AENC-NG-CNS-REP-0243

Norwich to Tilbury

**Document: 8.3.27 Draft Statement of Common Ground - Blackwater
Aggregates (Bradwell Quarry) - Tracked Changes Version**

Planning Inspectorate Reference: EN020027

Figure 1 Interface between Bradwell Quarry and the Project Alignment

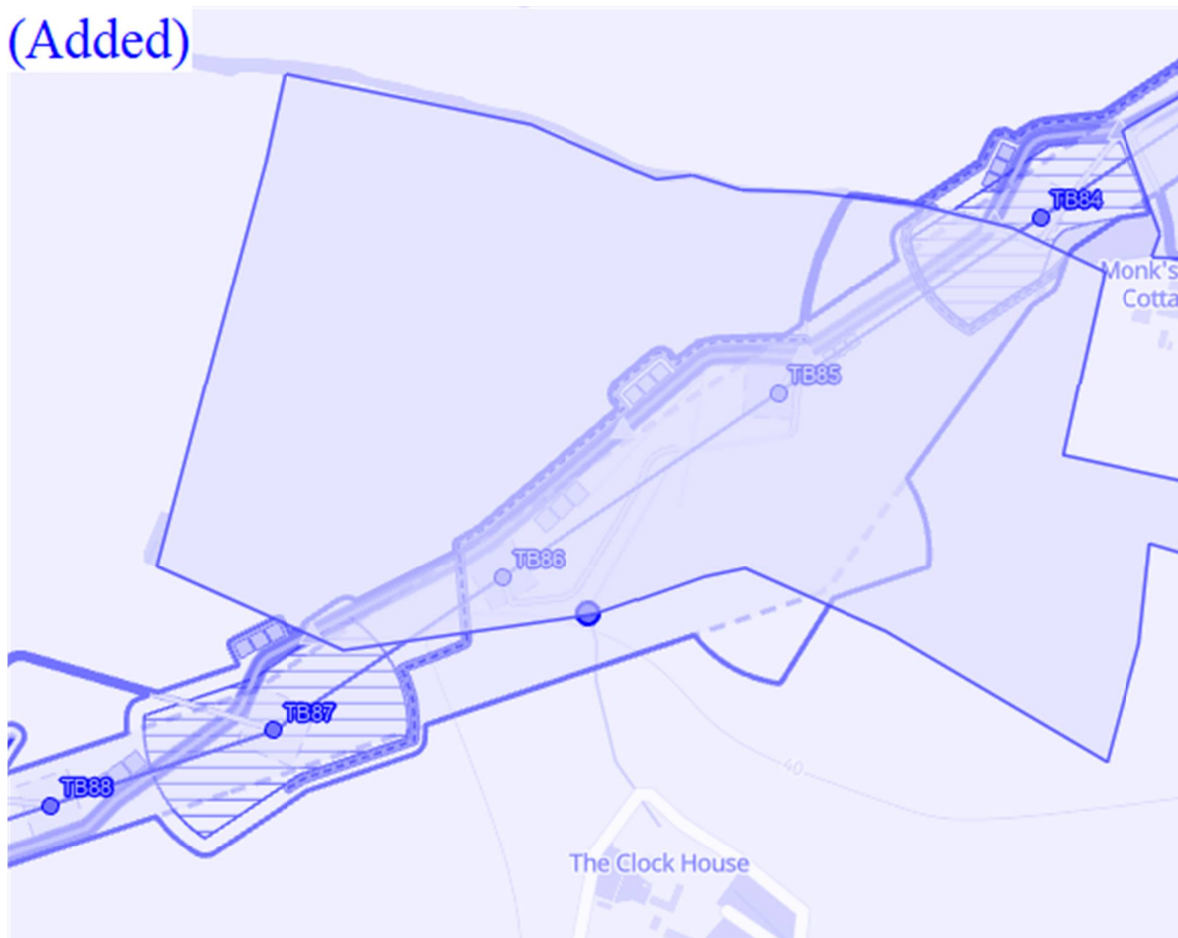
ID	Issue	National Grid Position	Stakeholder Position	Status	Relevant documentation
<u>6.17.1</u>	Route Scenarios	National Grid <u>The Applicant</u> has identified <u>the</u> interface between the Norwich to Tilbury project and the Bradwell Quarry Monks Farm development. As a result, NG identified <u>To accommodate ongoing discussions and potential changes to the planning status of the Monk's Farm site, the Applicant has developed</u> a design scenario that provides flexibility to respond to ongoing discussions, the potential change in planning status for the Monk's Farm site, and detailed designs between the two projects. A summary of the scenario has been included <u>for future adjustments. This scenario is summarised</u> in the Design	Blackwater Aggregates submitted the area 8 (area A47 Council ref.) for incorporation into the Mineral Local Plan. Consultation closed in July 2024, and BA await the outcome of the submission. <u>30/04/26 - Please can you explain why there are two blue lines (picture below) shown as a deviation from Monks Farm, heading south to a new pylon TB85). We</u>	Ongoing discussion with detailed design to be progressed.	ESS/12/20/BTE planning application with Essex County Council on behalf of Blackwater Aggregates. Essex County Council Mineral Local Plan Review – Assessment of Candidate Sand and Gravel Sites – A47 Bradwell, Monk's Farm Design

6.27.2	Permanent sterilisation of minerals under electrical infrastructure pillar of support	National Grid notes the potential change in planning status of the Monk's Farm site and the concerns from Blackwater Aggregates in relation to potential mineral sterilisation. As a result, NG identified a design scenario that provides flexibility to respond to ongoing discussions and detailed designs between the two interfaces. A summary of the scenario has been included in the Design Development Report (5.15) and Chapter	4 -NG to confirm the extent of the protective area around each pylon base if route on existing plans remains unaltered. BA have made clear, through previous consultations, questionnaires and site meetings with NG of the	Ongoing discussion with key points to be confirmed. 2 BA have requested the alignment is relocated towards the eastern and southern most

Figure 2 Alternative Project Alignment

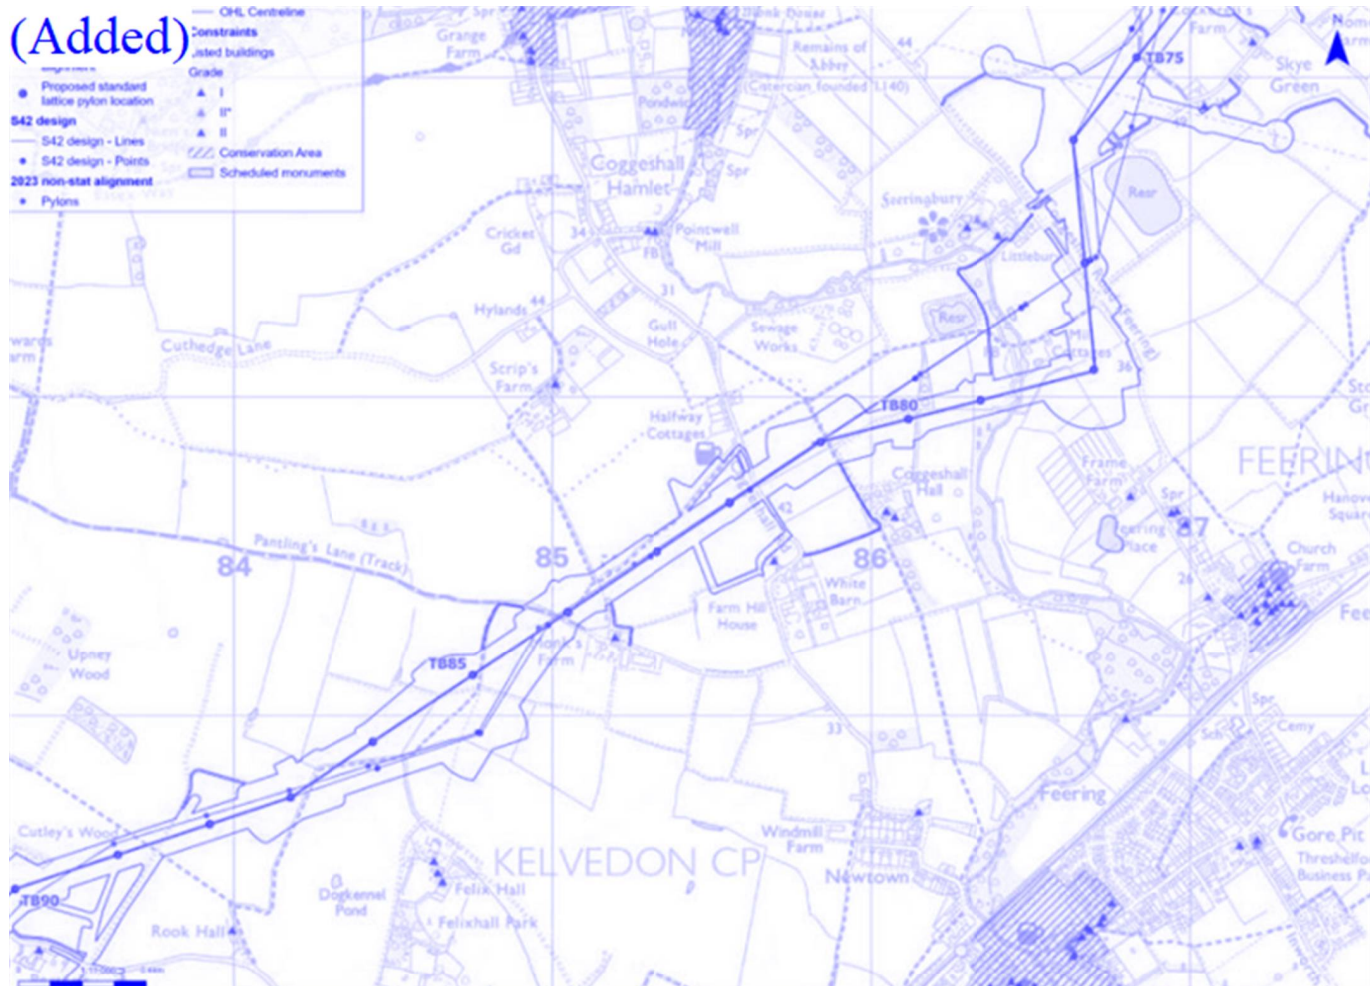
ID	Issue	National Grid Position	Stakeholder Position	Status	Relevant documentation
		<p>4 (Project Description) of the Environmental Statement (6.4) submitted with the DCO application. National Grid welcomes ongoing discussions with Blackwater Aggregates to continue to consider the scenario and detailed design.</p> <p><u>The Applicant has committed to the alternative option and will now progress with this as the preferred scenario. This has been confirmed to the ExA at Deadline 4 in (8.11) Approach to Scenarios document.</u></p>	<p>potential significant mineral sterilisation and consequential financial compensation claim arising if the scheme negatively impacts gravel extraction.</p>	<p>point within the route corridor. BA await revised plans from NG showing this re-alignment for further consideration.</p>	
<p>6.3<u>7.3</u></p>	<p>Alternative Routeing Scenario at Bradwell Quarry</p>	<p><u>An alternative scenario has been developed that adjusts the overhead line between TB084–TB087. This scenario moves TB086 and TB085 further south, with TB084 positioned closer to the Order Limits, to reduce sterilisation within the quarry. The Applicant considers that siting these pylons at the edge of the development area will lessen mineral sterilisation while maintaining construction access between TB084 and TB085.</u></p> <p><u>The Limits of Deviation have been widened to allow additional flexibility</u></p>	<p>4.BA were informed their suggestion to re-route to an alternative location within the corridor makes little or no marginal cost difference to the scheme. This would make a portion of the mineral reserve financially viable.</p>	<p>Ongoing discussion with key points to be confirmed.</p> <p>BA await revised plans from NG showing this re-alignment for further consideration.</p>

ID	Issue	National Grid Position	Stakeholder Position	Status	Relevant documentation
		<p><u>should further extraction opportunities arise.</u></p> <p>The alternative scenario modifies the overhead line route between TB084-TB087. From TB087 the alignment back to TB084 would be realigned to be more easterly such that TB086 moves south out of the proposed quarry area, TB085 also moves south but remains just within the quarry area at the narrowest point. TB084 moves to the southwest to just within the quarry boundary with an extended overhead line span to TB085. While noting that two pylons remain within the site, National Grid considers that the siting at the edge of the development area will reduce the extent of the sterilisation of minerals. It is anticipated that the timing of construction of each project will continue to allow construction access between TB084-TB085.</p> <p>TB082-TB083 may similarly be within minerals area but have been positioned as close to the boundary as routeing principles allow when considering all relevant factors. Likewise, the construction access has been aligned along the edge</p>

ID	Issue	National Grid Position	Stakeholder Position	Status	Relevant documentation
		<p>of the development area. National Grid considers that the siting at the edge of the development area will reduce the extent of the sterilisation of minerals.</p> <p>National Grid has extended the Limits of Deviation to facilitate a change in the route should the need arise to enable further extraction. <u>The Applicant has committed to the alternative option and will now progress with this as the preferred scenario. This has been confirmed to the ExA at Deadline 4 in (8.11) Approach to Scenarios document.</u></p>
